**Report: Deficiency Report**  
**Function: Test, Adjust, & Balance**  
**Date: 02/12/2025**  
**Completed By: National TAB**

**PROJECT**  
**02-10-25 WAWA #5459 STARKE, FL**

Project Issue File Details

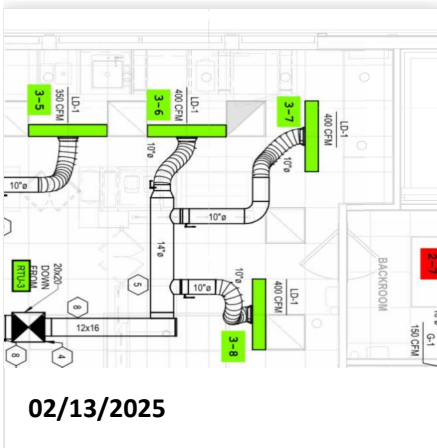
**Issue Name :** Diffuser 3-6 - No Damper  
**Description :** Damper is missing or could not be located for diffuser 3-6 (coffee/specialty beverage). Diffuser remains at 113% airflow. Recommend installing damper to allow for balancing.  
**Created By :** National TAB                      **Assigned To :** National TAB - Dan Hertenstein  
**Status :** Open  
**Priority :** Urgent                                      **Asset Tag :** SGRD6  
**Originated Date :** 02/13/2025 - Mark Johnson - National TAB

Project Issue File Details

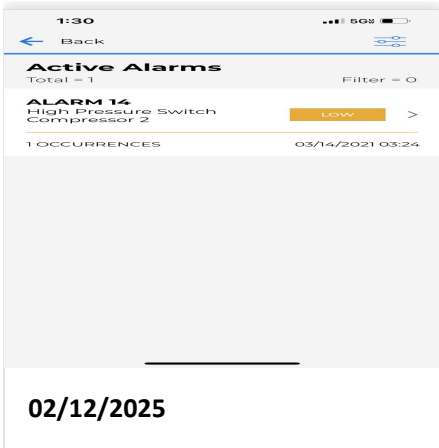
**Issue Name :** EFs - Not Powered  
**Description :** Exhaust fans are not yet powered. Must be running to allow for balancing.  
**Created By :** National TAB                      **Assigned To :** National TAB - Dan Hertenstein  
**Status :** Open  
**Priority :** Urgent                                      **Asset Tag :** EF1  
**Originated Date :** 02/12/2025 - Mark Johnson - National TAB
